<b>AMENDMENT OF SOLICITATION/MODIFICATION OF CONTRACT</b>			1. CONTRACT ID CODE	PAGE 1 OF 10 PAGES
2. AMENDMENT/MODIFICATION NO. AMENDMENT NO. 0002		3. EFFECTIVE DATE 01/19/12	4. REQUISITION/PURCHASE REQ. NO.	5. PROJECT NO. (If applicable) 11-0079
6. ISSUED BY CODE		jsy	7. ADMINISTERED BY (If other than Item 6) CODE See Item 6	
Officer in Charge of Construction MCI-East 1005 Michael Road Camp Lejeune, NC 28547-2521				
8. NAME AND ADDRESS OF CONTRACTOR (No., street, county, State and ZIP Code)			(X)	9A. AMENDMENT OF SOLICITATION NO. N40085-11-R-0079
			X	9B. DATED (SEE ITEM 11) 12/20/11
				10A. MODIFICATION OF CONTRACT/ORDER NO.
				10B. DATED (SEE ITEM 11)
CODE	FACILITY CODE

11-0079, Install Modular Buildings at Onslow Beach, Phase VI

**CONTINUATION SHEET**

# FLOOR JOIST LAYOUT

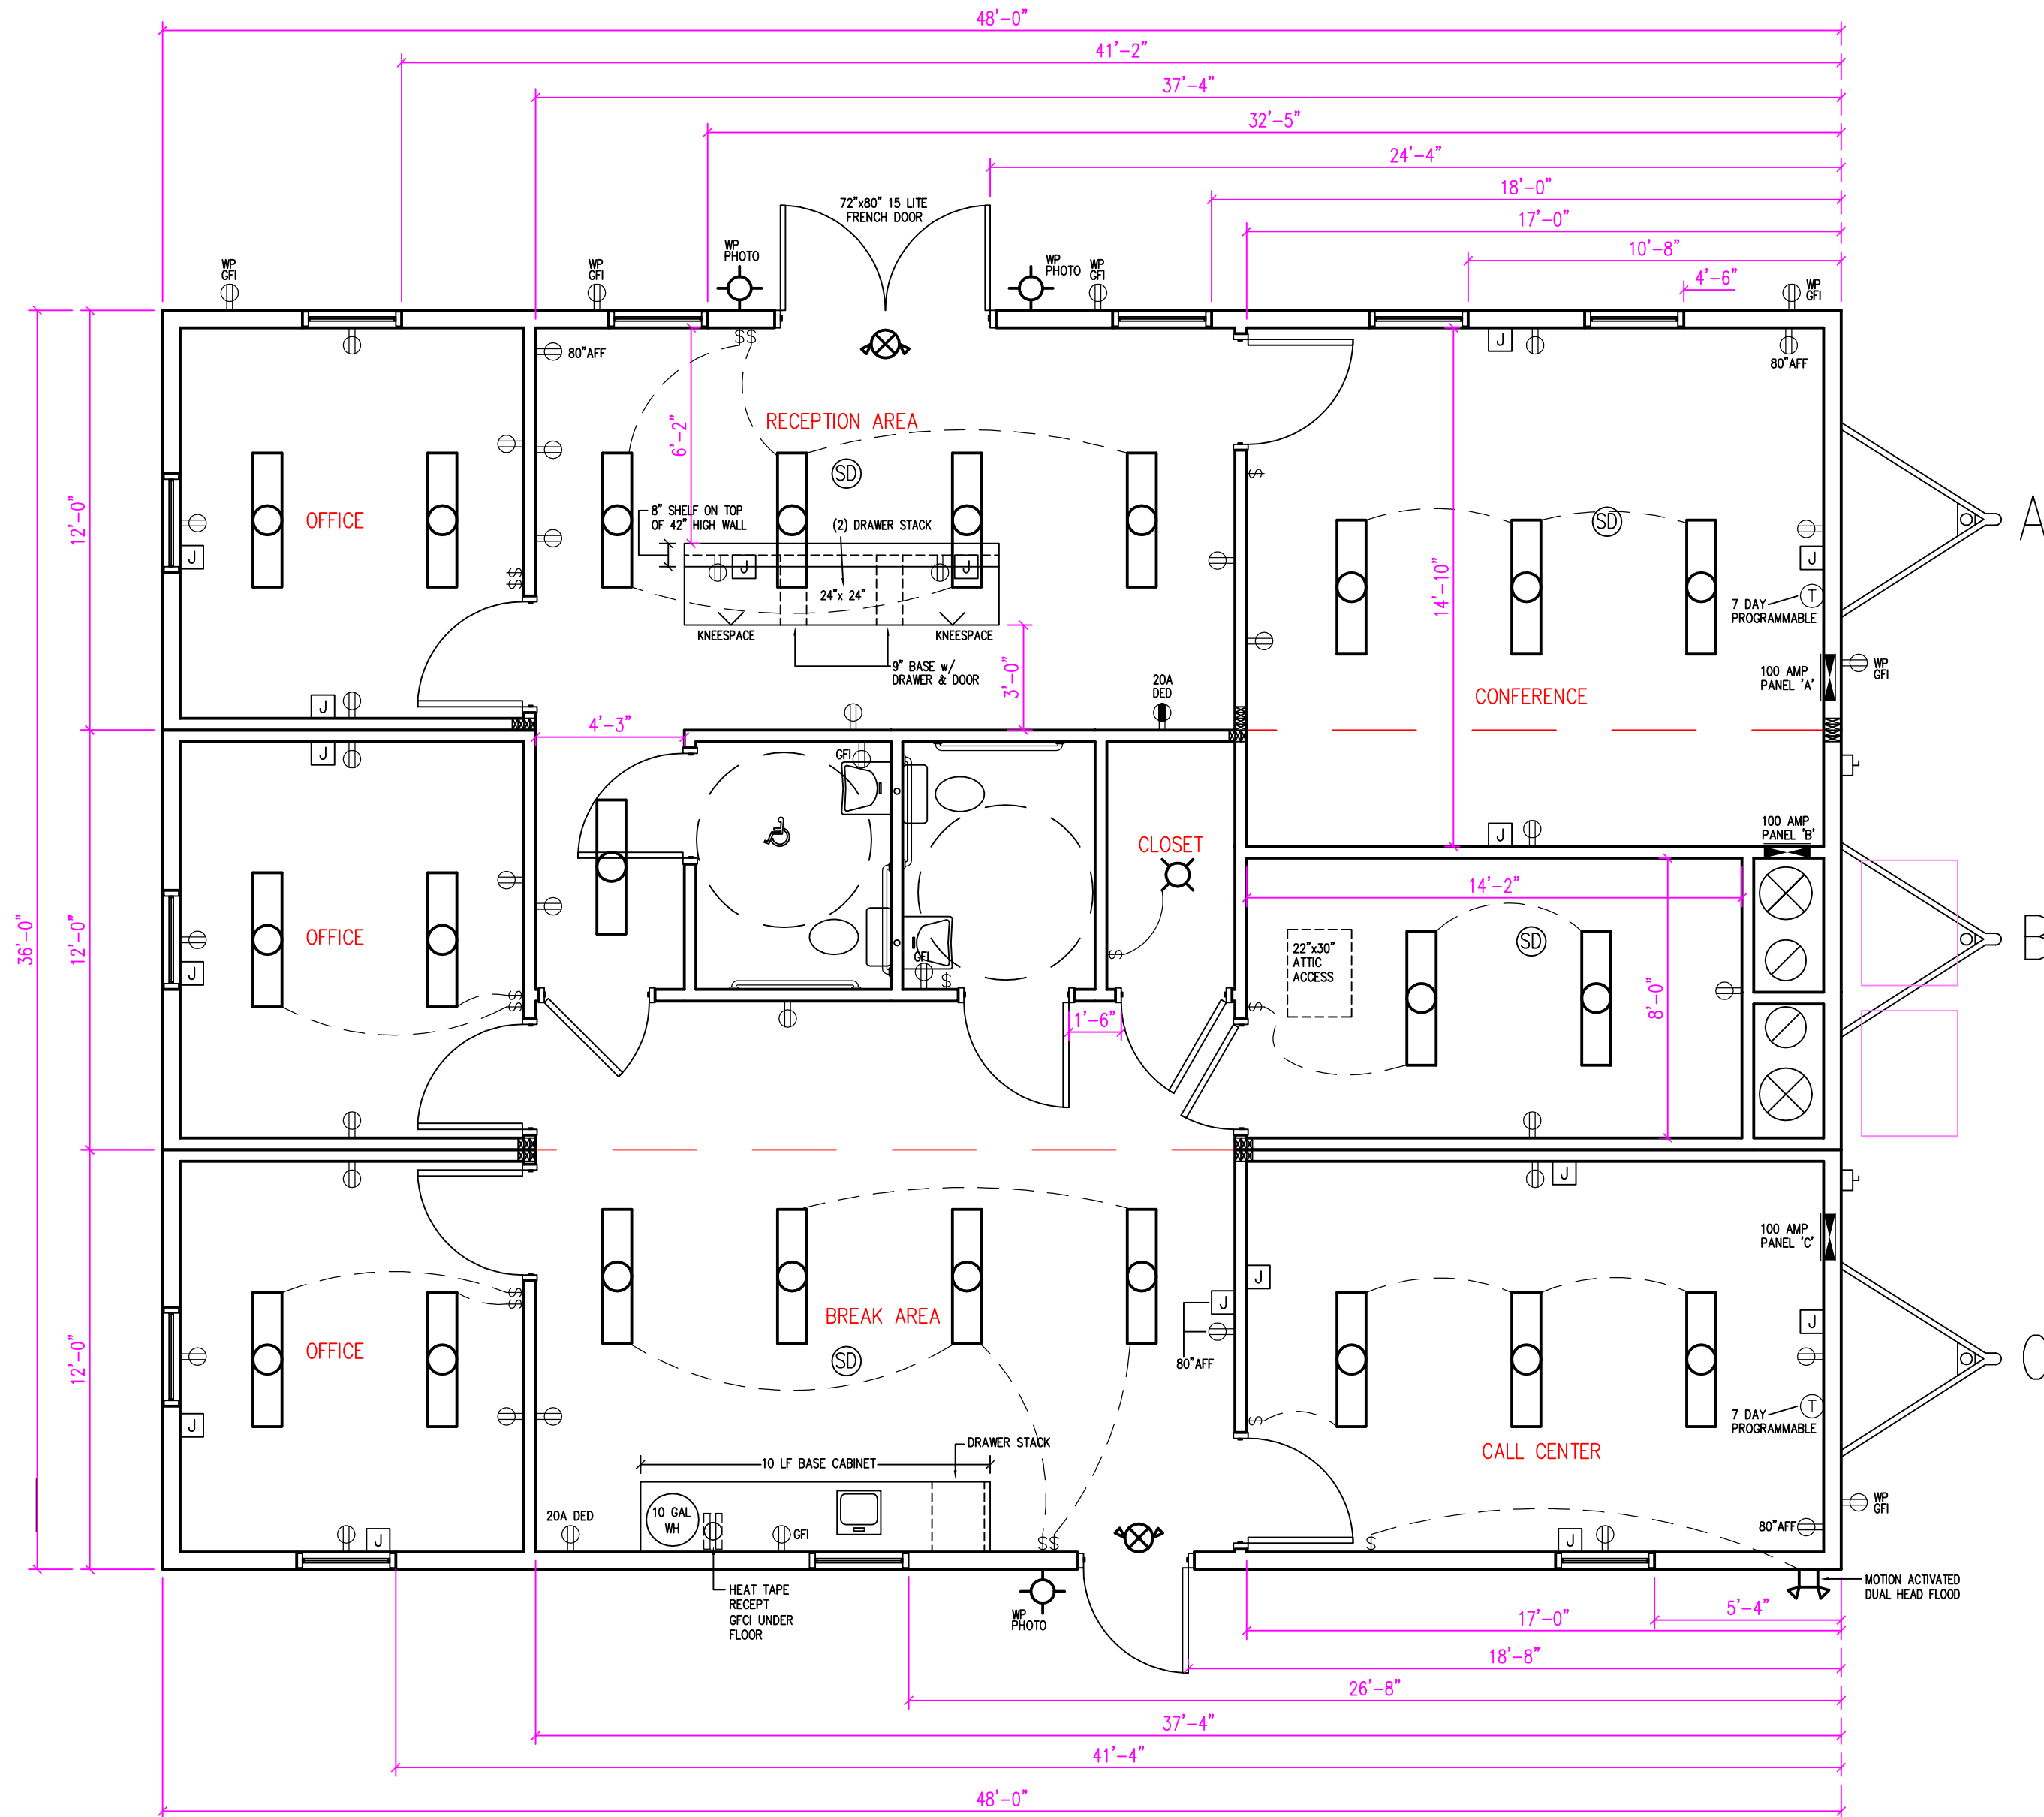
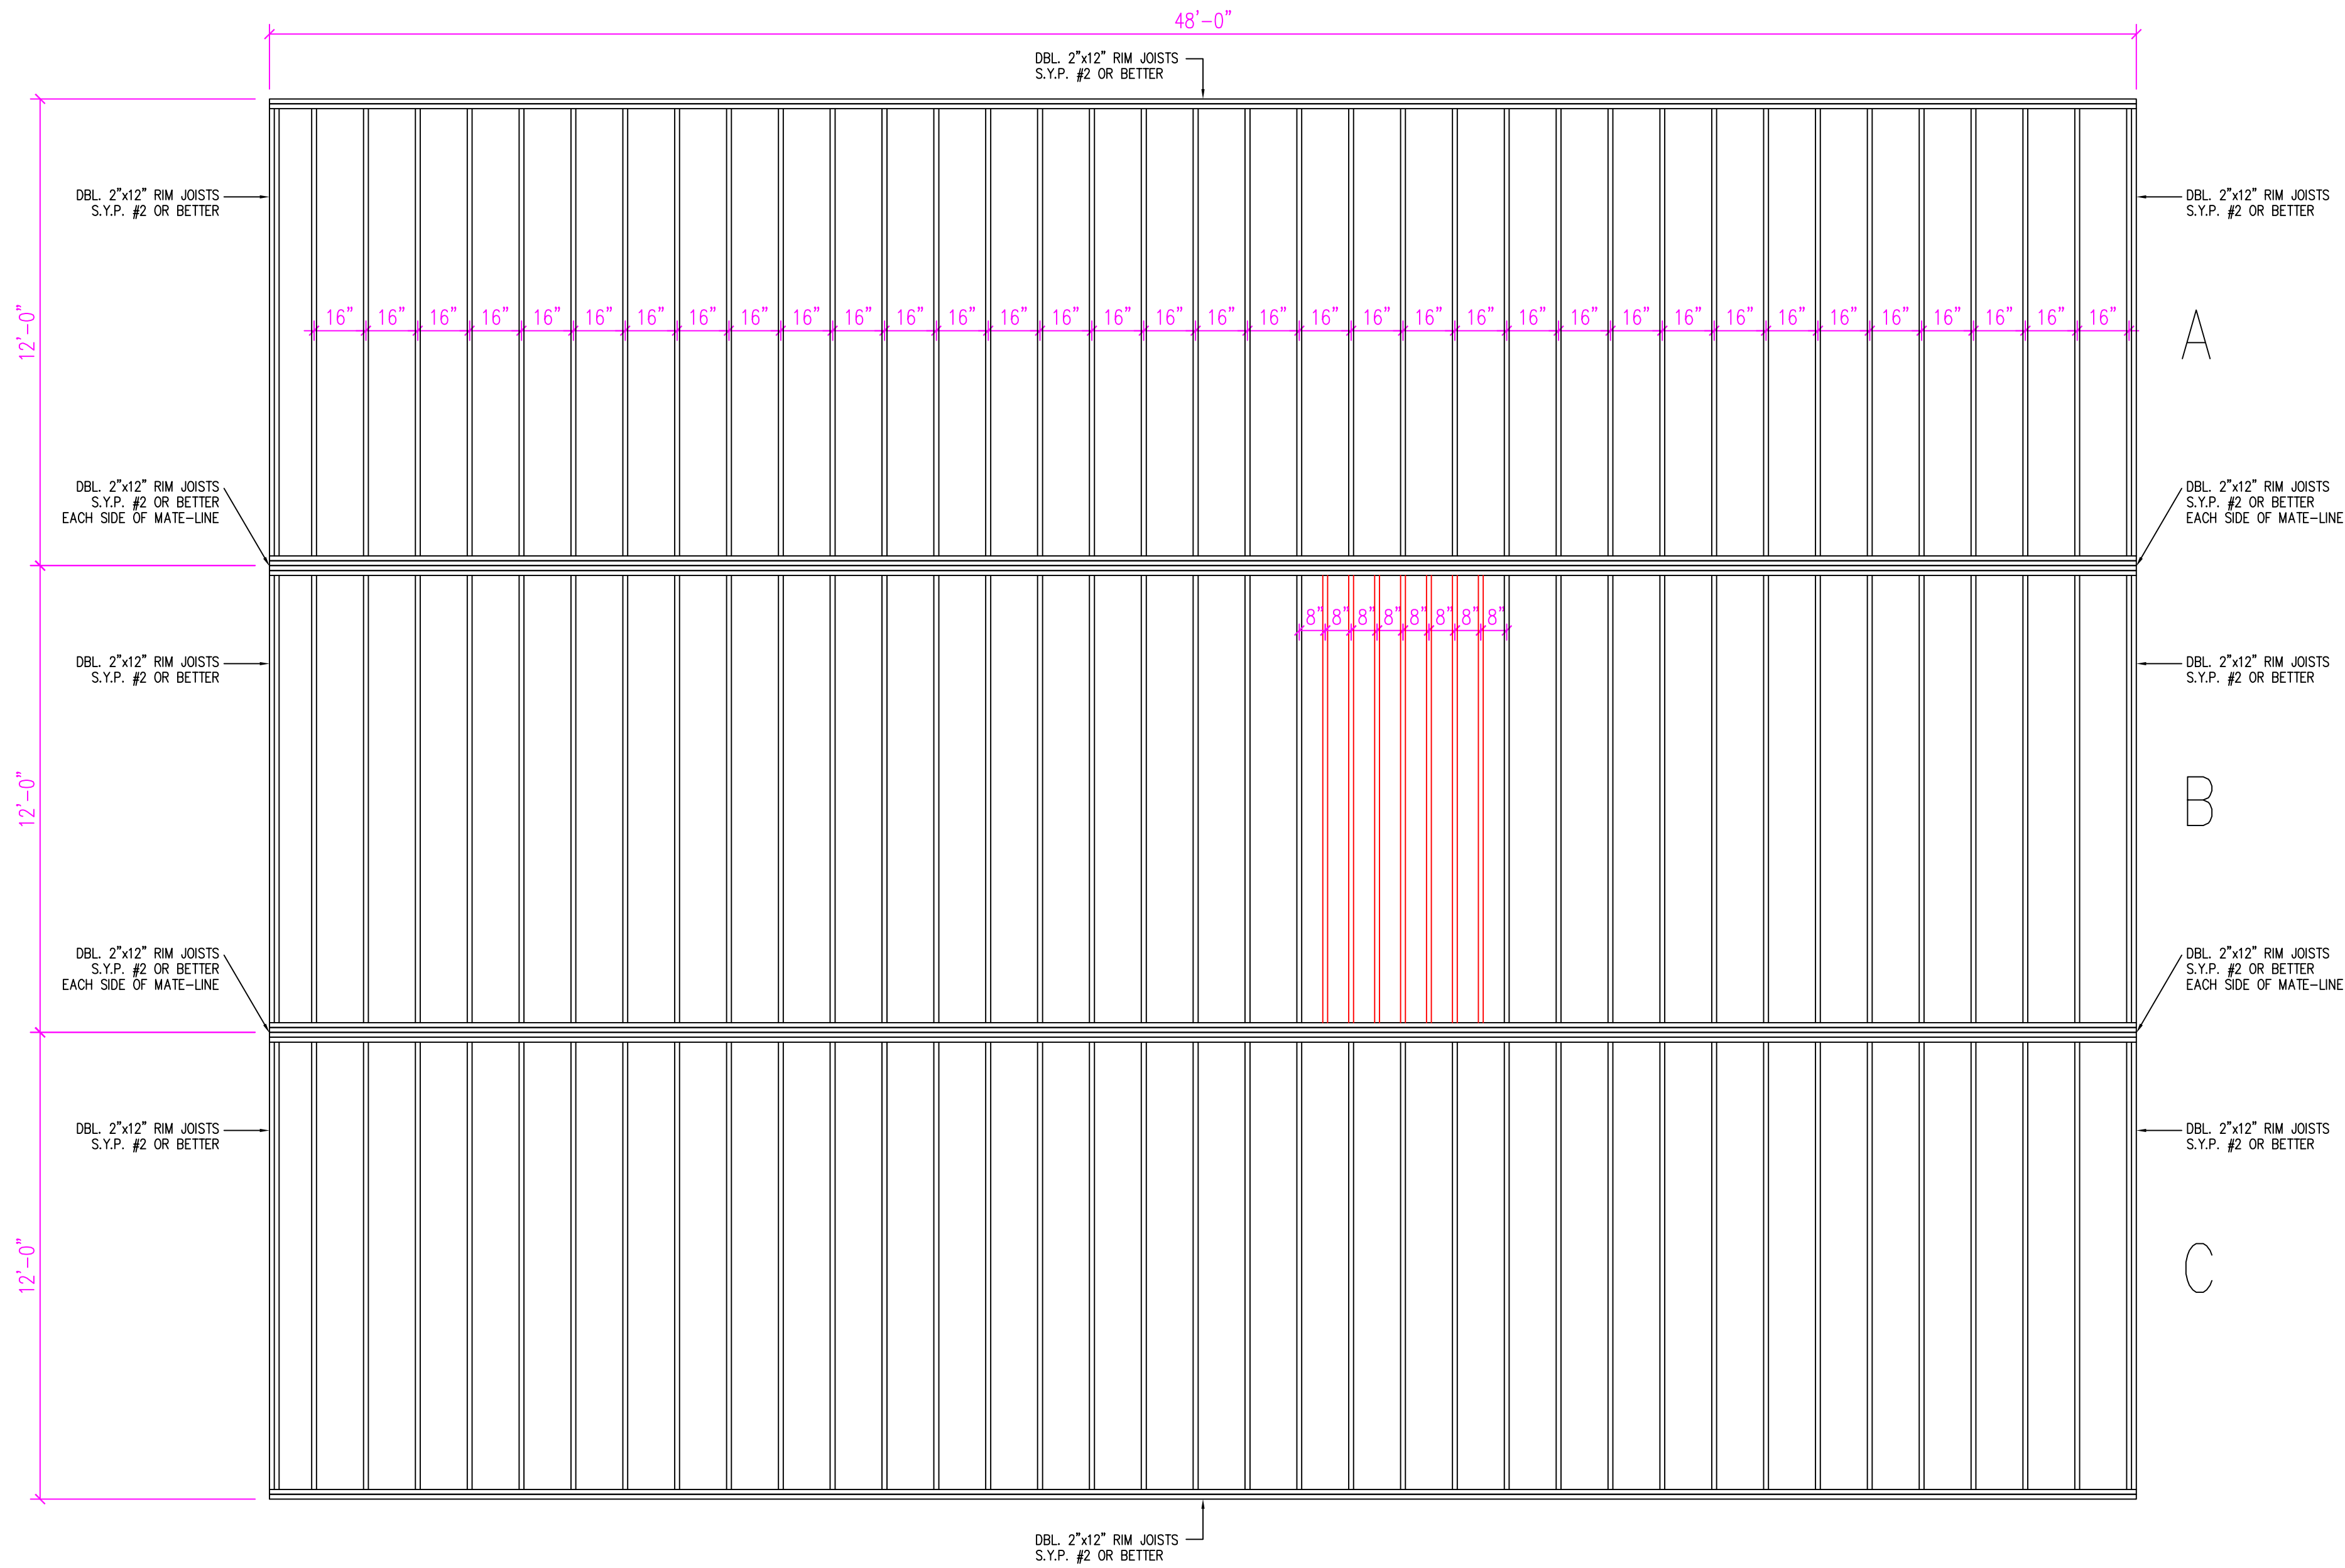
**1 Question:** I need plans & specs from manufacturer of modular units.

**4 Question:** Please provide shop drawings of modular units to be provided by government.

**26 Question:** Please provide diagrams and instructions from the manufacturer of the modular units showing requirements and procedures for setup of the units. Need details for tying in the mechanical, electrical and plumbing.

**1 Answer:** See attached drawings, (pages 8 through 10).

**4 Answer:** See attached drawings, (pages 8 through 10).

**26 Answer:** See attached drawings, (pages 8 through 10).
